# **Model for Failure of RCP Seals Given Loss of Seal Cooling in CE NSSS Plants**

**WCAP-16175-NP-A, Rev. 0**

SUBJECT: FINAL SAFETY EVALUATION FOR PRESSURIZED WATER REACTOR OWNERS GROUP (PWROG) TOPICAL REPORT WCAP-16175-P, REVISION 0, (CE NPSD-1199, REVISION 1) "MODEL FOR FAILURE OF RCP SEALS GIVEN LOSS OF SEAL COOLING IN CE NSSS PLANTS" (TAC NO. MB5803)

**Figure 3.3-1  
Typical CBO Configuration for a CE Plant**

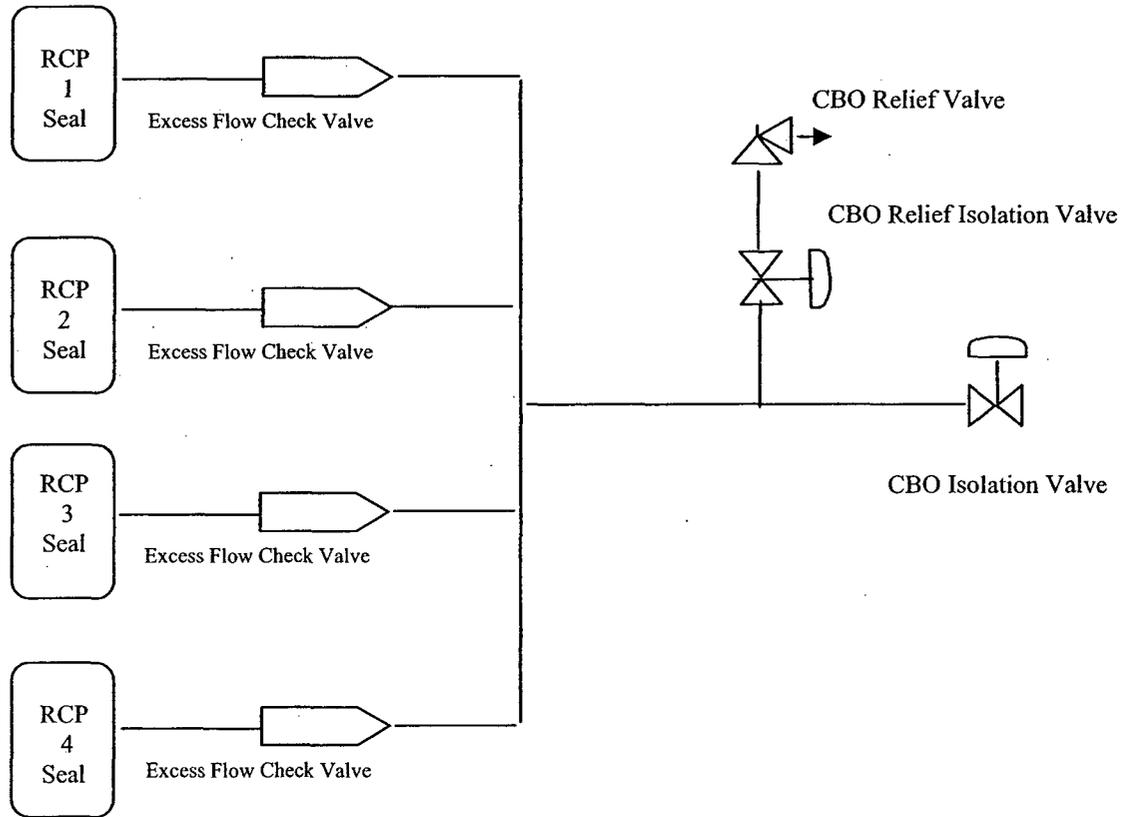
<b>Response</b>	The CBO isolation line relief valve flow rate is 22 gpm. This value has been added to Table 3.3-1.
<i>pg. 3-10</i>	<i>Figure 3.3-1 misidentifies the third RCP as RCP 4; it should be RCP 3.</i>
<b>Response</b>	Figure 3.3-1 was corrected.
<i>pg. 4-1 § 4.1 ¶ 1</i>	<i>This section divides RCP seal failures into three categories. Please clarify how each of these failure categories is reflected in the RCP seal failure model in Chapter 6. If a category is not reflected, please provide a justification for why this category of failures does not need to be considered in the RCP seal failure model.</i>
<b>Response</b>	Section 4.1 provides a discussion of operating failures encountered during the early years of plant operation to indicate the type of problems that lead to concerns about RCP seal reliability. The model presented in this report is for RCP seal failure given loss of seal cooling. The other operational failure mechanisms are addressed only implicitly in the model to the extent that they could contribute to the potential for a pre-existing stage failure or a random stage failure.

Figure B2-1: Idealized RCP Seal Stage Force Balance

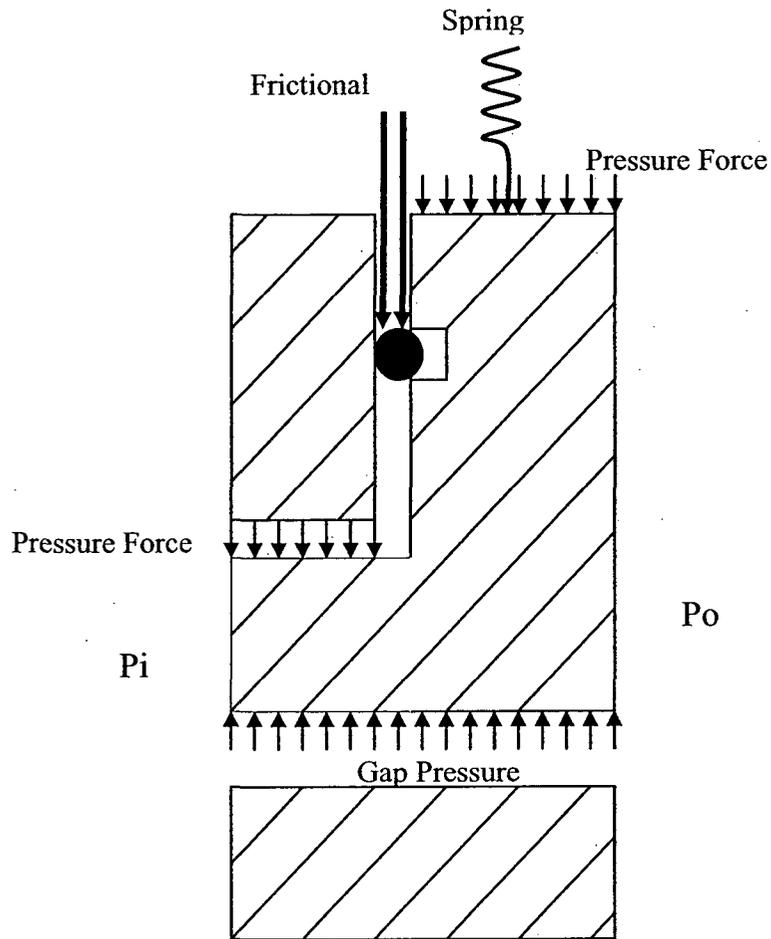
**RAI 2.1 Response:** Evaluation of seal events on CE PWRs indicates that the middle seal stages are the more likely to experience "pop-open." While small leakages may be observed through the vapor seal, no catastrophic failure has been noted. Although detailed thermal-hydraulic behavior could not be confirmed for most of these events, it is expected that vapor seal operation was in or near saturation for conditions where CBO was not isolated. Experimental data with CBO operation is limited. However, tests conducted by Byron-Jackson for the loss of component cooling water (Reference B2.1) and for station blackout (Reference B2.2) seal performance also indicated periods of two-phase and near two phase conditions in a vapor seal while seal leakage remained small (< 0.5 gpm). Specifically, the RCP seal cartridge was operated for a period of 30 minutes without seal cooling in one loss of coolant test. The seal cartridge remained operational and the controlled bleedoff (CBO) was not isolated during the test interval. A review of the seal temperature and pressure data indicates a period of ~10 minutes where the vapor cavity was nearly saturated (within ~10°F of saturation) or saturated. Vapor seal leakage measurements conducted at the time indicated seal leakage of less than 0.26 gpm. No "pop-open" behavior was observed, even though the backpressure to vapor seal cavity pressure ratio was much less than one half. The total upward force ( $F_{up}$ ) exerted by the fluid in the seal gap was compared to the total downward (restorative) force ( $F_{tot}$ ) acting on the RCP seal upper face for the N-9000 seal design. This comparison demonstrated that at these lower absolute pressure conditions the upward force generated in the seal by the seal leakage is insufficient to overcome the downward seal force and hence the seal would not "pop-open."

The conceptual seal design is presented in Figure B2-1. The downward force is a result of the combined upstream and downstream pressure loads on associated areas, friction and spring load. The upward (or opening) force is based on the fluid pressure in the seal gap. The capability of the seal to remain closed under a pressure differential is based on a balance between the total downward force ( $F_{tot}$ ) and upward gap pressure force ( $F_{up}$ ) assuming that the pressure of a two-phase mixture results in a critical flow condition in the seal gap.
